»» Service Letter

Number: L18-01 B
REPLACES L18-01A

Subject: Superior PMA Replacement Cylinder Assemblies With Corrosion Resistant Steel Exhaust Port Studs for Continental Motors, Inc. 520 and 550 Series Engines

Figure 1 SA657985-1.38 CRS Stud

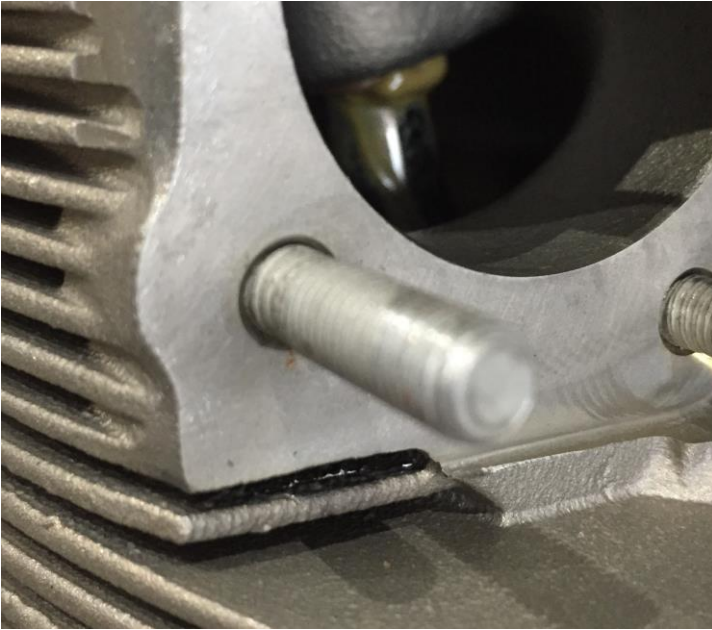
As a product improvement, Superior has begun installing P/N SA657985-1.38 corrosion resistant steel (CRS) exhaust port studs in its PMA replacement cylinder assemblies for Continental Motors, Inc. (CMI) 520 and 550 series engines, replacing the P/N SA638125 and SA640482 alloy steel studs. These cylinder assemblies and their engine eligibilities are listed in the table below. The P/N SA657985-1.38 stud is also available in the P003, P007 and P012 oversizes for repair purposes. Figures 1 and 2 provide photos of installed P/N SA657985-1.38 and P/N SA638125 (same as the P/N SA640482 except installation height) studs for identification purposes.

Caution: The P/N SA657985-1.38 and oversize interference fit studs are not interchangeable with the SA638125 and SA640482 ring lock studs.

As noted above, the P/N SA657985-1.38 (and oversizes P003, P007, and P012) is an interference fit stud as opposed to the P/N SA638125 and P/N SA640482 ring lock type studs formerly used in the CMI 520 and 550 series Superior PMA replacement cylinder assemblies. The type of studs in your 520 or 550 cylinder(s) may be identified by referring to figures 1 and 2.

- 1) Using a suitable stud removing tool, remove the damaged studs.
- 2) Chase the threads with a ¼-20 UNC-3B tap.
- 3) Apply Lubriplate 105 or equivalent to the ¼-20 threads on the P/N SA657985-1.38 stud and, using an appropriate stud driving tool, drive the stud to a height of .875 ± .030 inch. The minimum allowable driving torque is 15 in-lbs. If this minimum torque is not achieved, repeat the installation using a P/N SA657985-1.38 P003 stud. The holes may also be tapped to ¼-20 P007 or ¼-20 P012 and the corresponding oversize stud installed.

A minimum driving torque of 15 in-lbs must be achieved.

Cylinder assemblies with P/N SA638125 or SA640482 ring lock studs must be repaired using P/N SA638125 or SA640482 ring lock studs. Do not replace either the P/N SA638125 or P/N SA640482 ring lock stud with a P/N SA657985-1.38 interference stud.
